MAXIMUM SERVICE TELEVISION

Re: OET Testing of Unlicensed Devices; ET Docket No. 04-186

Proposed Modifications/Additions to the Tests Conducted by the FCC to Evaluate the Performance of Prototype TV-Band White Space Devices

Deficiencies in the OET Test Plan to Evaluate the Performance of Prototype TV-Band White Space Devices

Figure 1: I²R white-space sensing device

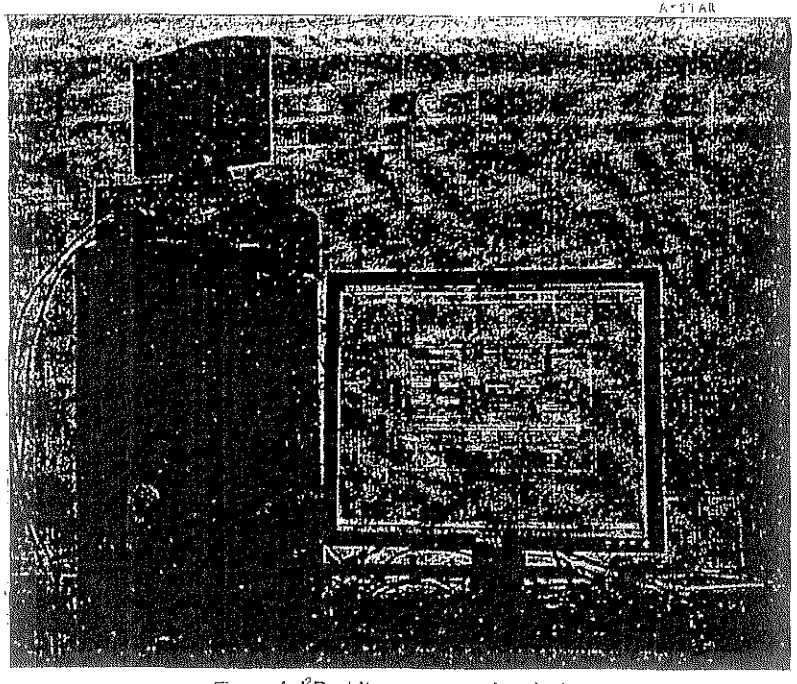
- How do you take the antenna performance into account for sensing level
- Moore's law holds for electronics not antenna performance
- Not a particularly practical personal portable antenna design
